REMARKS/ARGUMENTS

AMENDMENTS TO THE FIGURES

Appl. No. 09/181,533
Amdt. dated April 7, 2004
Reply to Office Action of October 9, 2003

Corrected Fig. 4

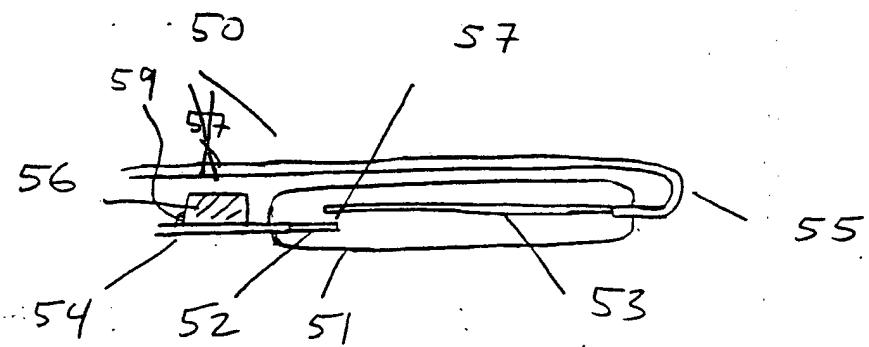
1. Fig. 4. Error: Item number 57 appears twice in the Figure. Number 57 at the center of the page designating air gap 57 is correct; the number 57 that appears between numbers 59 and 50 at the upper left portion of Fig. 4 is in error and should be deleted. Support for this correction may be found in the specification as filed at p.10, lines 5-6 and line 17.

Corrected Fig 5

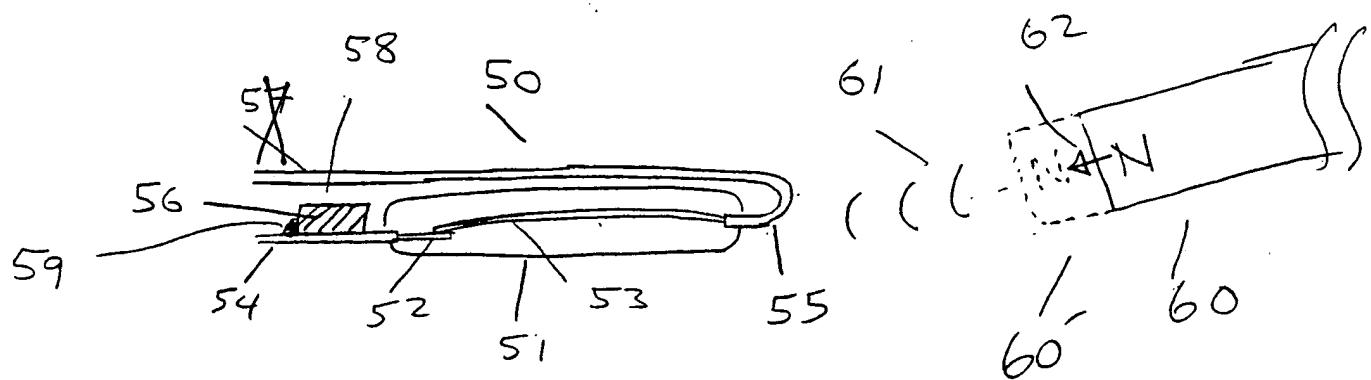
2. Fig. 5. Error: Item number 57 is in error and should be deleted. Fig. 5 shows the latchable reed switch of the present invention in the "closed" position (p.8, lines 2-3). In the closed position, the reeds of the reed switch come together, eliminating the presence of any air gap. Thus, there is no air gap between reeds 52 and 53 in Fig. 5, and number 57 should be deleted. Support in the specification may be found at p.10, lines 5-6 and line 17.

Corrected Fig 6

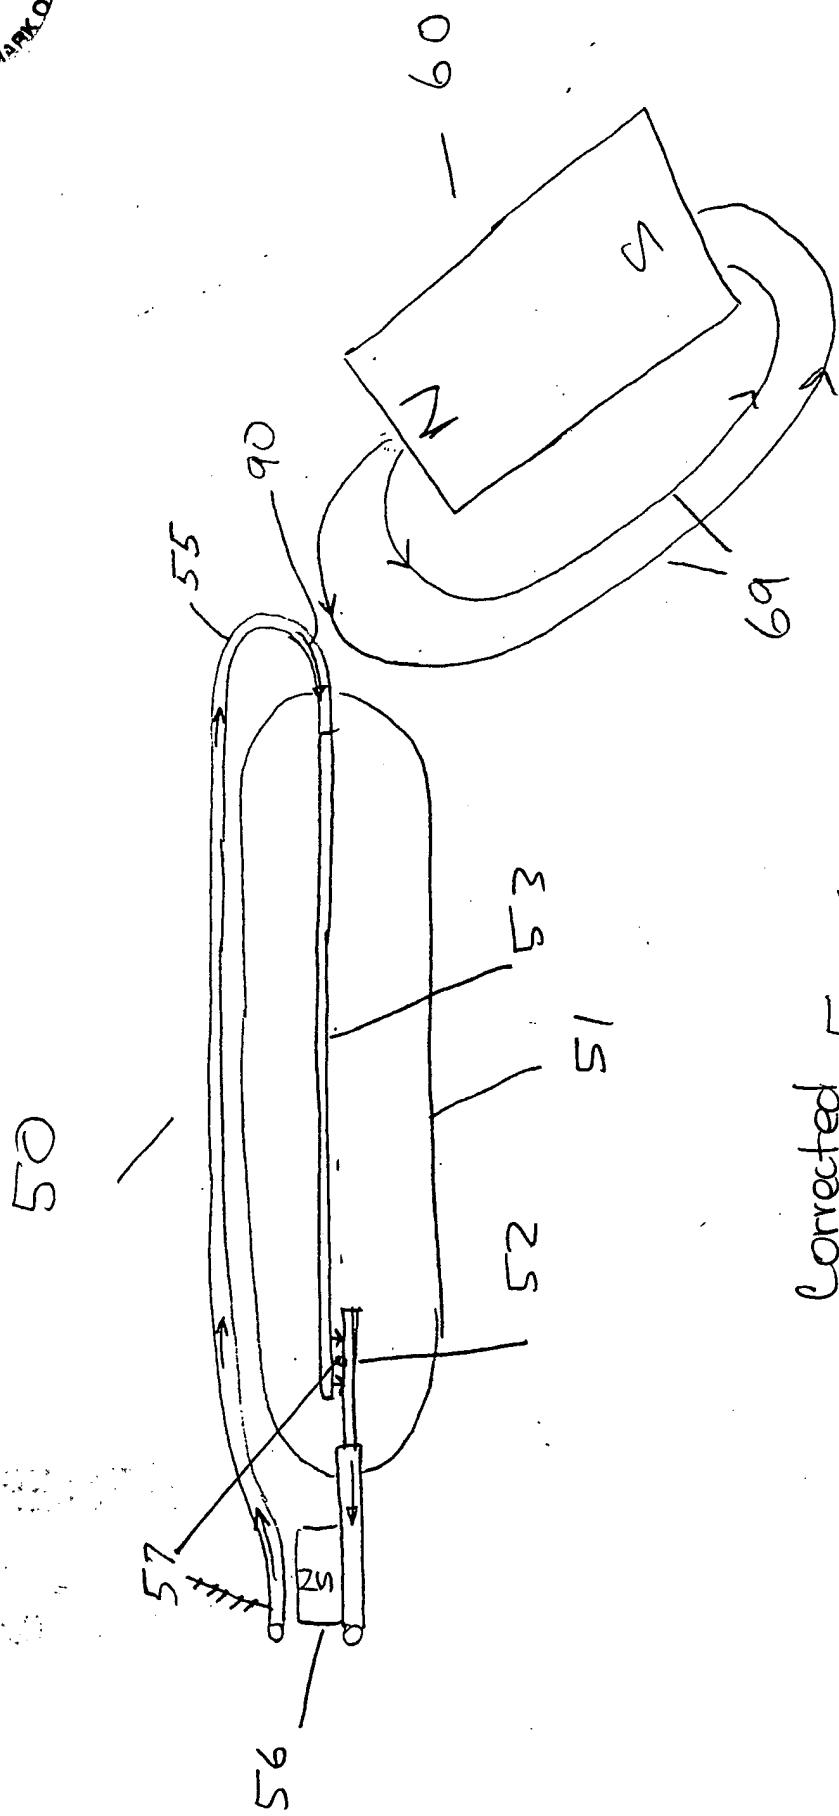
3. Fig. 6. Error: Item number 57 is shown incorrectly. Item 57, the air gap between the reeds of the reed switch, should correctly point to the space between reed 52 and reed 53. For support, see the specification as filed at p.10, lines 5-6 and line 17.

Corrected Fig. 8

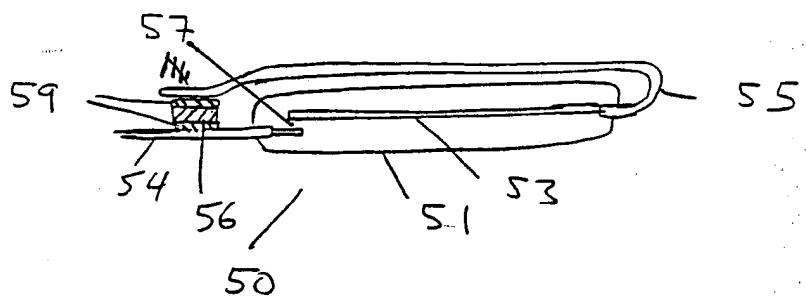
4. Fig. 8. Error: Item number 57 is shown incorrectly. Item 57, the air gap between the reeds of the reed switch, should correctly point to the space between reed 53 and reed connected to lead 54, which is unnumbered in Fig. 8. For support, see the specification as filed at p.10, lines 5-6 and line 17.
